Stage 03: Report to the Authority

National Electricity Transmission System Security and Quality of Supply Standards (NETS SQSS)

GSR025: Updating the SQSS to reflect the recent modification to Engineering Recommendation P28

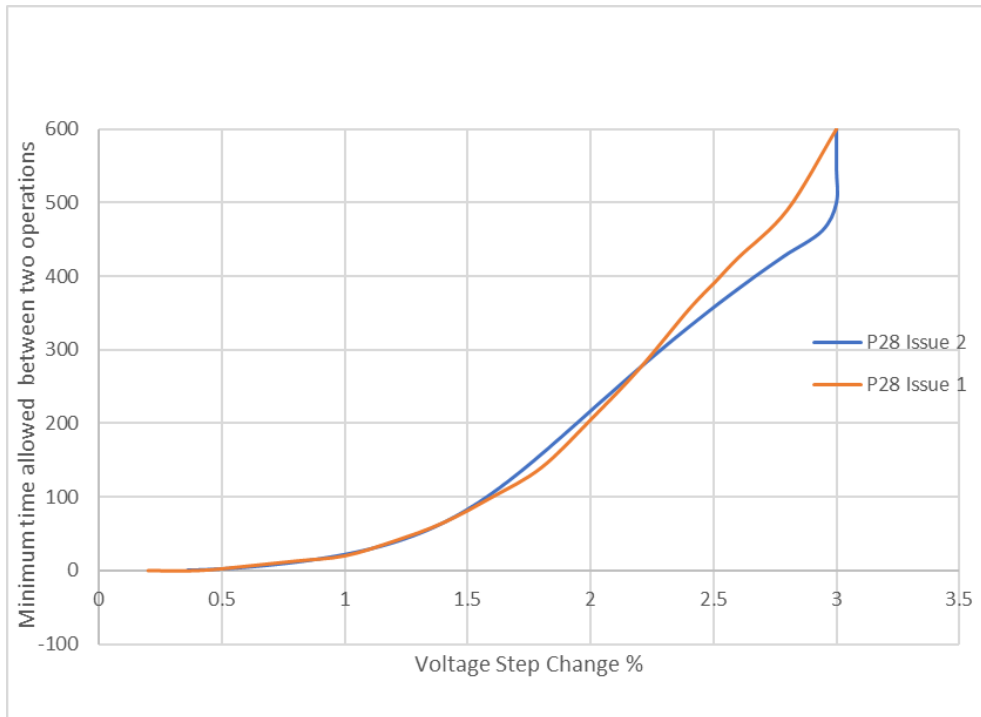
3.1 The minimum time required between two consecutive operations causing a Voltage Step Change of a specific level are shown in Figure 1 below for both P28 Issue 1 and Issue 2.

Figure 6.1 Maximum Voltage Step Changes Permitted for *Operational Switching* derived from ER^{EP} P28 B.1.2

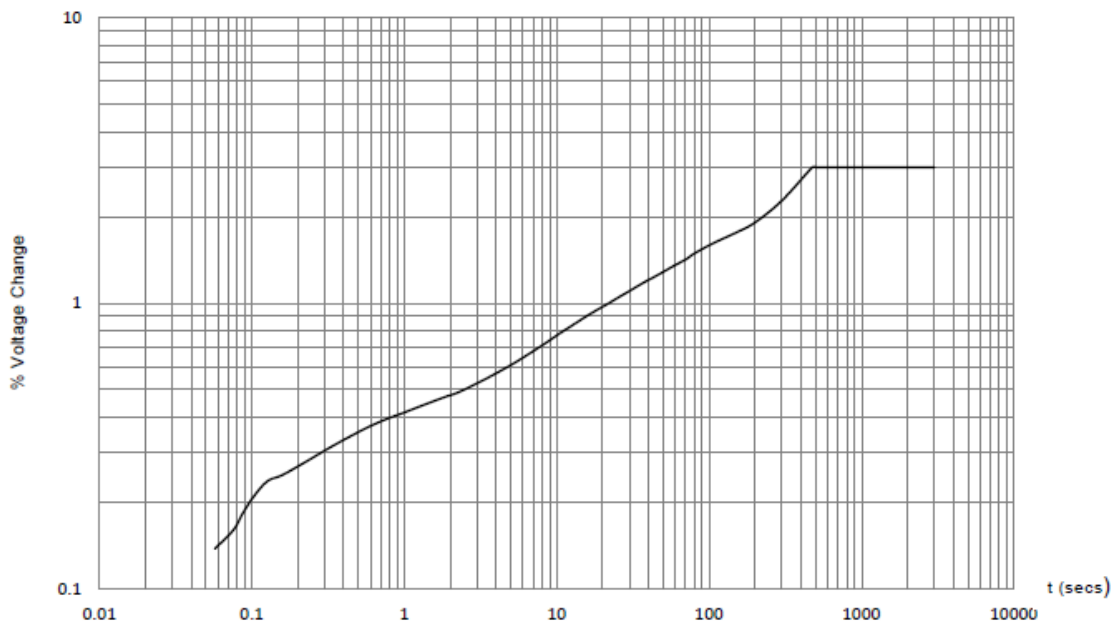
1.10 Therefore, a sequential modification is required to the SQSS to update the reference to the minimum time interval between voltage changes in Table 6.5 and to change Figure 6. which has been updated in Issue 2 of P28. It is proposed that the minor changes are made to Table 6.5 and a new diagram should replace Figure 6.1.

- Change the 10 minutes referred to in Row 1 and Row 2 of Table 6.5 of the NETS SQSS to 8 minutes; and
- Replace Figure 6.1 of the NETS SQSS by a new Figure 6.1 which is based on Figure B1.2 of the new EREC P28 Issue 2.
